Access Compliance Report

Public Rights-of-Way

(Curb Ramps)

Intersection ID: 19405	Main Street: DUNFRIES_RD	Cross Street: MARGARET_WALLACE_RD	Location: SW
ADA ID: 6016A0CE60C1	Ramp Type: PerpDiag	Initial Pass/Fail: Fail	Overall Compliance: No
Severity Score: 25			
Codes/Mitigation Info/Possible Solution		Field Measurements/Component Compliance

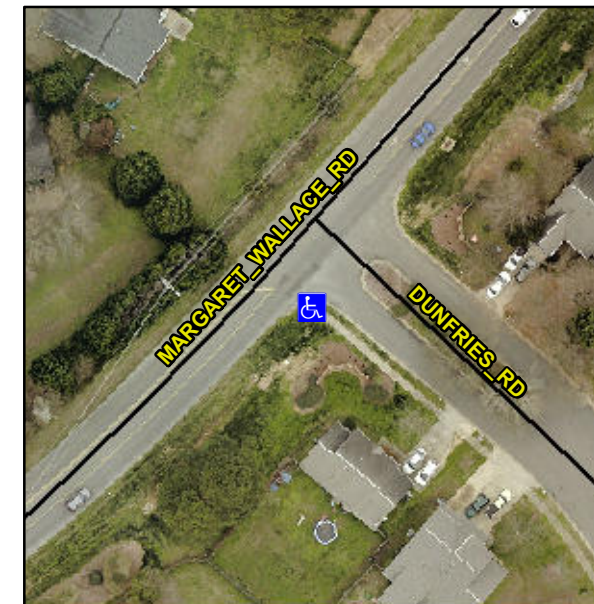
Remove & Replace Curb Ramp With Two New Directional Ramps or Equivalent.

R304.2.2

Compliance	Description	Data	Compliance	Description	Data
N/A	Ramp Length (in)	48.0	No	Ramp Slope (%)	12.3
Yes	Ramp Width (in)	48.0	Yes	Ramp XSlope (%)	1.2
N/A	Flare Type LT	N/A	N/A	Flare Type RT	N/A
N/A	Flare Slope LT (%)	N/A	N/A	Flare Slope RT (%)	N/A
N/A	Flare Traversable LT?	N/A	N/A	Flare Traversable RT?	N/A
N/A	Landing Length (in)	N/A	N/A	DWS Provided?	N/A
N/A	Landing Width (in)	N/A	N/A	DWS Contrast?	N/A
N/A	Landing Slope (%)	N/A	N/A	DWS Length (in)	N/A
N/A	Landing X Slope (%)	N/A	N/A	DWS Full Width?	N/A
N/A	Landing Curb? (Y/N)	N/A	N/A	DWS Offset (in)	N/A
N/A	Shared Landing?	N/A			
N/A	Gutter Ponding?	N/A	N/A	Gutter Slope (%)	N/A
N/A	Gutter Lip Ht (in)	N/A	N/A	Gutter X Slope (%)	N/A
N/A	Painted X Walk1?	No	N/A	Painted X Walk2?	No
	X Walk 1 Direction	To NE		X Walk 2 Direction	To NW
N/A	X Walk 1 Width (in)	N/A	N/A	X Walk 2 Width (in)	N/A
	X Walk 1 Slope (%)	4.6		X Walk 2 Slope (%)	5.8
	X Walk 1 X Slope (%)	3.5		X Walk 2 X Slope (%)	0.7
